Just sharing a couple of suggestions/ideas here on the above-referenced project.

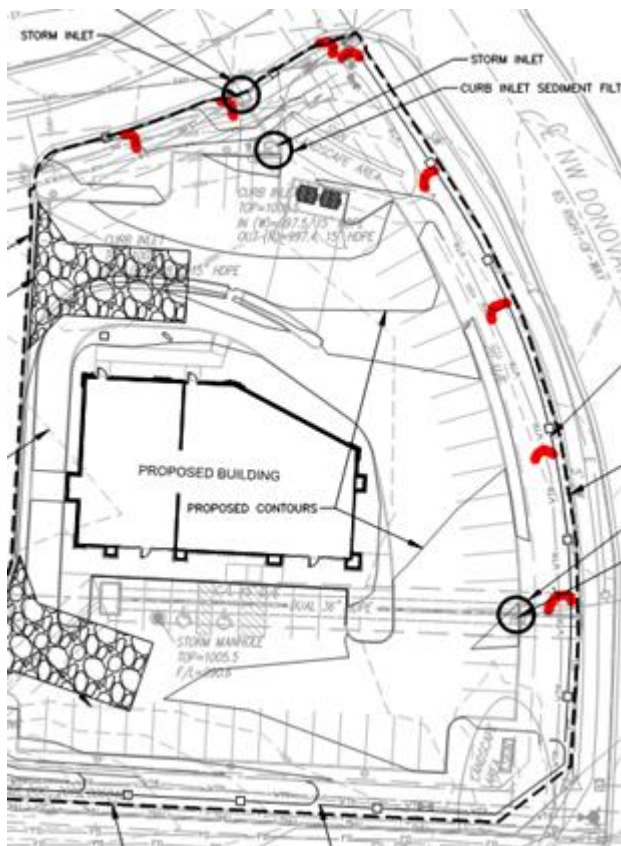
- Silt fence J-hooks also need to face uphill (approximately) as shown below. **The silt fence has been changed to show the J-hooks as shown below.**
